### **COMMENTS TO REQUEST FOR REVIEW FOR THE JOINT DOCUMENT, AMERICAN RIVER COMMON FEATURES, 2016 FLOOD RISK MANAGEMENT PROJECT, SCH#2005072046, SACRAMENTO AND YOLO COUNTIES**

Pursuant to the State Clearinghouse's 22 December 2023 request, the Central Valley Regional Water Quality Control Board (Central Valley Water Board) has reviewed the *Request for Review for the Joint Document* for the American River Common Features, 2016 Flood Risk Management Project, located in Sacramento and Yolo Counties.

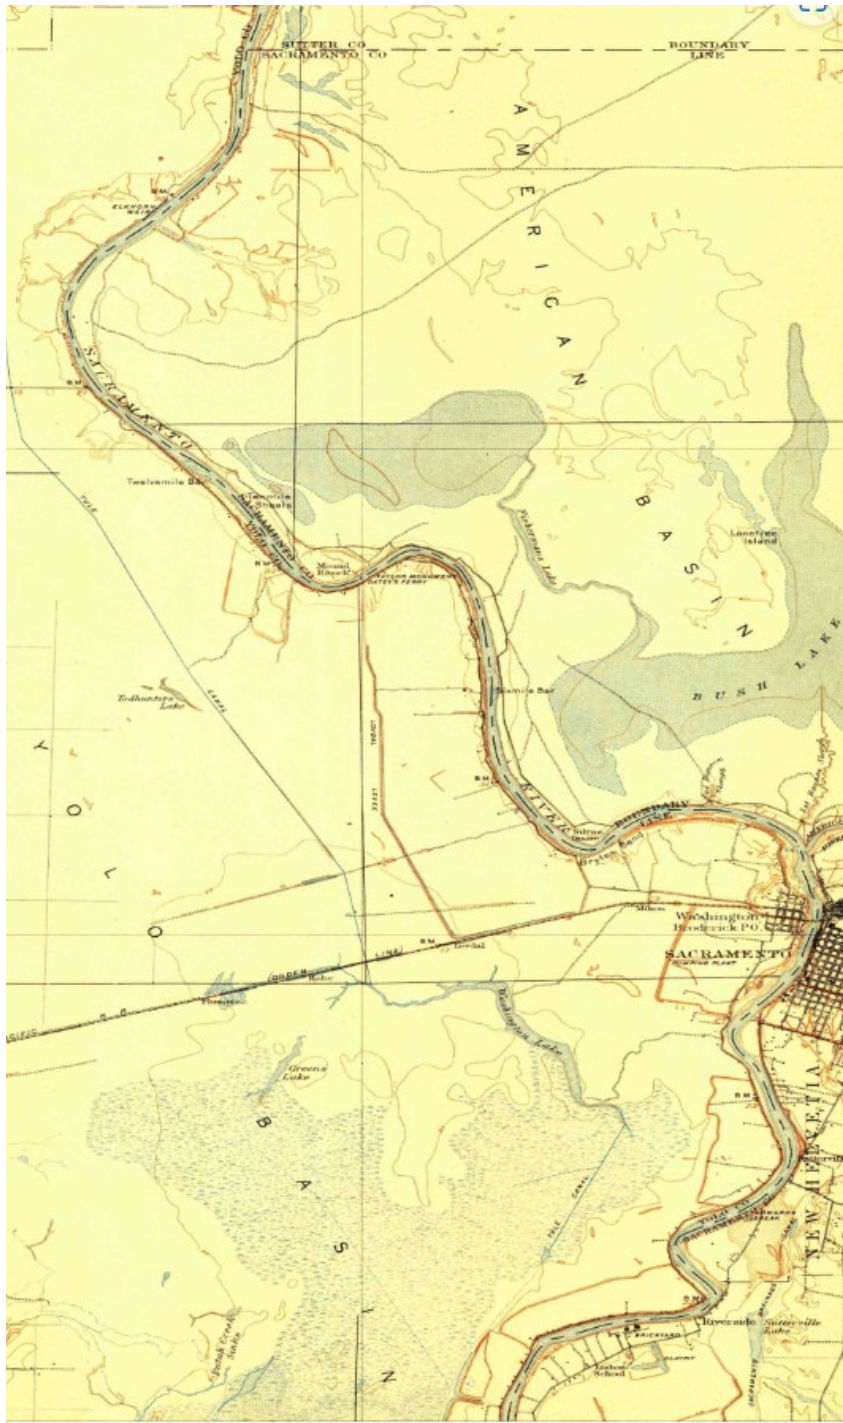
Historically, the confluence region had several open water ponds and lake habitat surrounding the area that were obliterated as a result of the levees and development. It is irrelevant that this pond is manmade. It should be thought of as a mitigation for the loss of the historical water bodies that were in the area and has become a critical landscape feature for so many species. A map from 1907 (below) shows a very large Bushy Lake connected to Fisherman's Lake in Natomas. Bannan's Slough was connected to Bush Lake and the Sacramento River. This was just north of the Urrutia property. It appears the channelization and levee building (NEMDC) destroyed this connection and associated aquatic habitats. Retaining the Urrutia pond is barely a drop in the bucket for waterbirds along the flyway, turtles, snakes, beavers, and other species that have seen so much habitat conversion and loss.

A map from 1906 (below) shows three additional lakes in the landscape that no longer exist. This map also illustrates the historical condition of the Urrutia property, which shows a creek flowing across the lands associated with the Urrutia Site and joining the American River at the downstream side of the site. Along the creek channel there appear to be two areas where water ponded, and it seems likely these features were important areas for the indigenous people that historically inhabited the area. The creek and its confluence with the American River were ultimately severed

and channelized into what is now the Natomas East Main Drainage Channel and Bannon Slough, which destroyed the associated aquatic habitats. However, the landscape still seems to provide some evidence of these historical conditions at the Urrutia Site. The document fails to recognize the limited amount of off-channel open water habitat that is present in the Parkway and regionally and that this is important habitat for migrating waterbirds.
